State of New Mexico
 Energy, Minerals and Natural Resources

Form C-103
 Revised August 1, 2011

E W WALDEN 12

**WELLBORE DIAGRAM
E.W. WALDEN #12
PROPOSED**

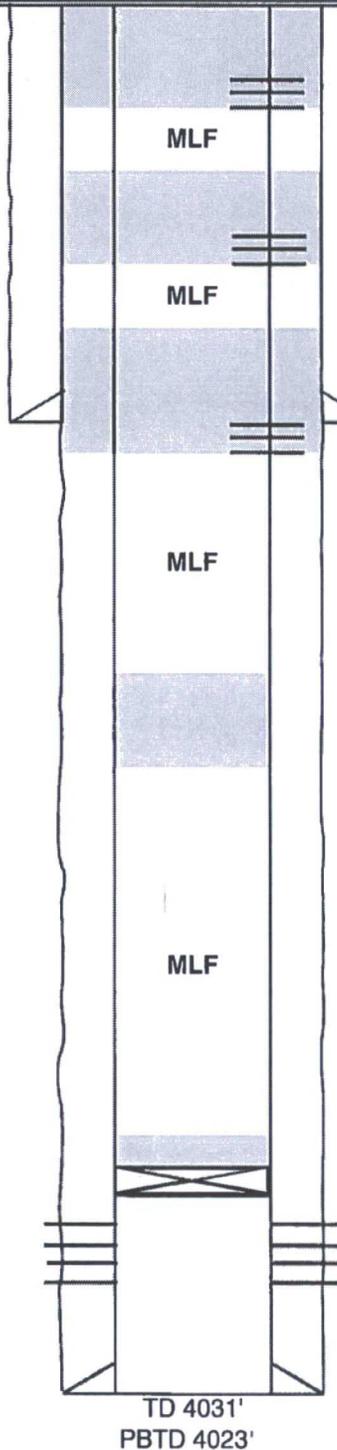
- This well was down hole commingled in 1999 and also is in R-5003 AREA.*
1. Call and notify NMOCD 24 hrs. before operations begin.
 2. MIRU. NDWH. NU BOPE. *3. Set CIBP@ 3960. CAPW/5sx.*
 - 120* 3A. Set CIBP@3,600' and spot 25sx of cmt. on top. Circulate well w/9.5 ppg mud. Pressure test casing.
 4. Spot 25sx of Class "C" cement from 2,455' - *2,255'*, WOC&Tag. (B.Salt) *1278'*
 5. Perf and squeeze 55sx of Class "C" cement from 1,268'-1,066', WOC&Tag. (T.Salt/Shoe)
 6. Perf and squeeze 55sx of Class "C" cement from 850'-650', WOC&Tag. (Security)
 7. Perf and squeeze 150sx of Class "C" cement from 400' to surface. (FW/surface)
 8. Verify cement to surface on all casings. Cut off wellhead and anchors 3' below grade. Weld on dryhole marker and clean location.
- Closed loop above ground tank system will be used for fluids.

For State Use Only
 APPROVED BY: *Mark Whitman* TITLE Petroleum Engr. Specialist DATE 04/27/2017
 Conditions of Approval (if any):

mw
